Recall Repair Instructions

NHTSA Recall # 26V-156

Tiffin Recall # TIF-147

Purpose: Replace incorrect OCCC label with a correct OCCC label.

Figure 1

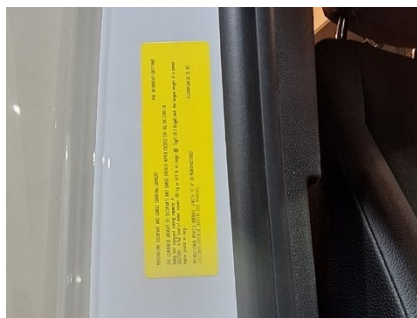
1. The yellow Cargo Carrying Capacity Label can be found on the passenger’s side door panel Figure 1.
2. Remove the old label and discard
3. Clean the passenger's side door jamb with isopropyl alcohol and carefully place the new label as shown

in Figure 2.
